MIL-M-63321A(AR)
AMENDMENT 2
19 November 1982
SUPERSEDING
AMENDMENT 1
25 March 1982

MILITARY SPECIFICATION

MICROCIRCUIT, DIGITAL, CMOS (FINAL LOGIC)

FIGURE 11. Burn-in and steady state of life test circuit.

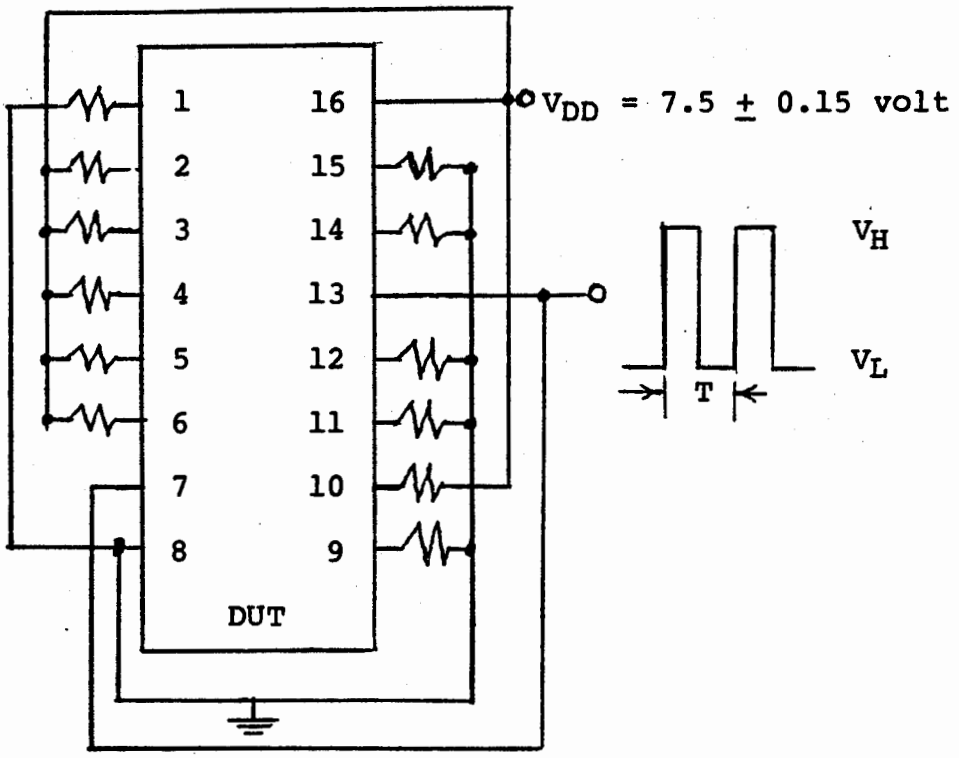
FIGURE 11: Delete present and substitute revised FIGURE 11 attached to this amendment.

V_H = 7.5 -.15 volts

V_L = 0.5 ± 0.15 volts

T = 40± 4uS period, 50% duty factor.

All R(s) = 51K ohms max.
